Core Bus Corridor 15: Blackrock to Merrion - Preliminary Submission

Dublin Cycling Campaign is a registered charity that advocates for better cycling conditions in Dublin. Dublin Cycling Campaign is the leading member of Cyclist.ie, the Irish Cycling Advocacy Network (ICAN). We want to make Dublin a safe and friendly place for everyone of all ages to cycle.

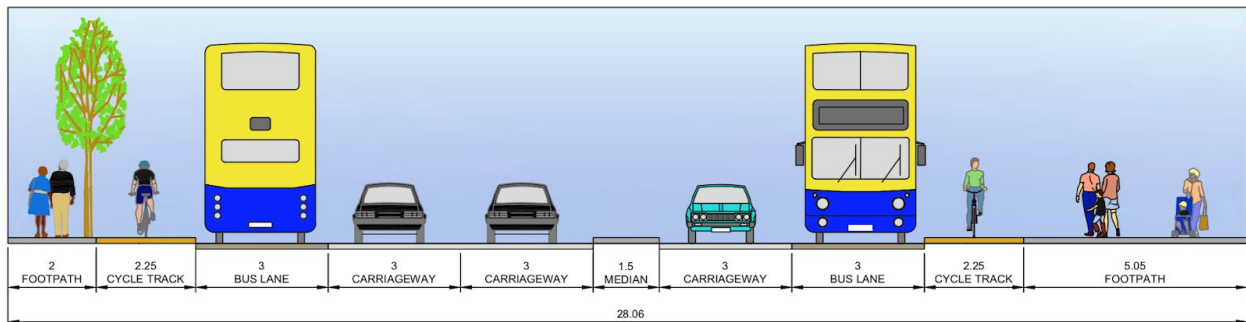
Bus stop bypasses for cyclists should be the norm as part of these designs. This is not currently the case for all bus stops. Some are and some aren't. In some cases it is a matter of reviewing bus stop locations, in others it is a matter of using the full available width.

Extract of the Sandymount to Blackrock Public Consultation, October 2016, showing 2.25m one-way cycle tracks

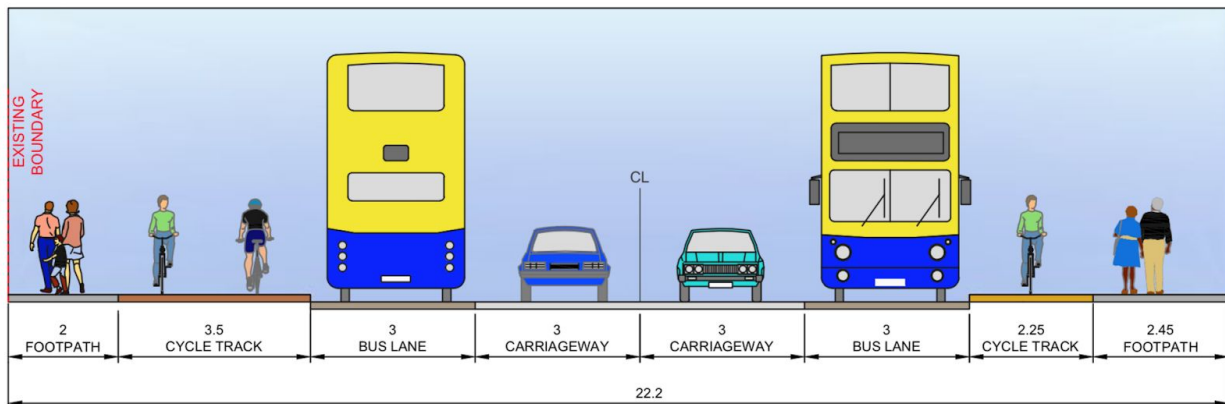
These proposals are an altered version of the Sandymount to Blackrock Cycle Scheme that the NTA put out to public consultation in October 2016. Those proposals included higher-quality cycle proposals than this Core Bus Corridor. The one way cycle tracks in that scheme were 2.25m wide where possible in many locations. Given that this is Primary Route 13A of the GDA Cycle Network Plan, the one way cycle track should aim to be more than 2m, where possible. It is requested that the national cycle manual advice - <https://www.cyclemanual.ie/manual/thebasics/width/> - is followed in this case and the one way cycle tracks are minimum 2.5m in width.

Extract of the Sandymount to Blackrock Public Consultation, October 2016, with continuous dedicated cycle facilities

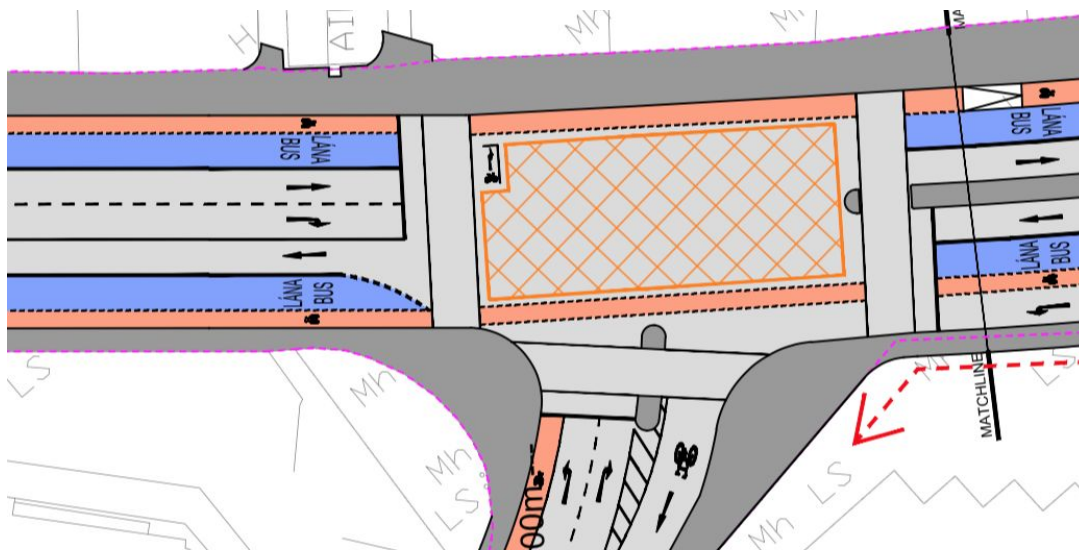
Although the Nutley Lane Junction is just outside this CBC on CBC14: UCD we will comment on it here too. The previous public consultation and the feasibility designs from AECOM included continuous dedicated cycle lanes through the junction.

Extract of CBC14: UCD public consultation document showing loss of the outbound dedicated cycle facility in order to make space for a bus priority light

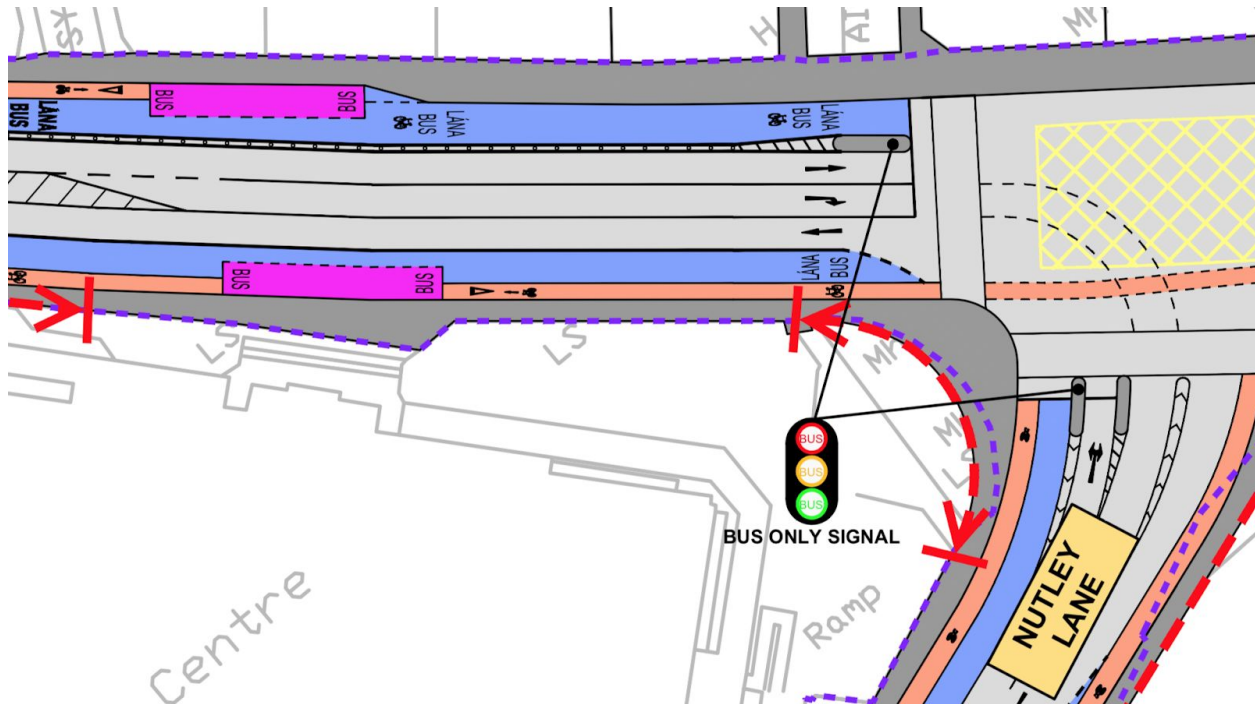
These dedicated cycle facilities have been compromised for a traffic island for bus priority lights. We understand the need for bus priority lights for right turning buses, however, it must not come at the cost of dedicated cycle facilities at this location.
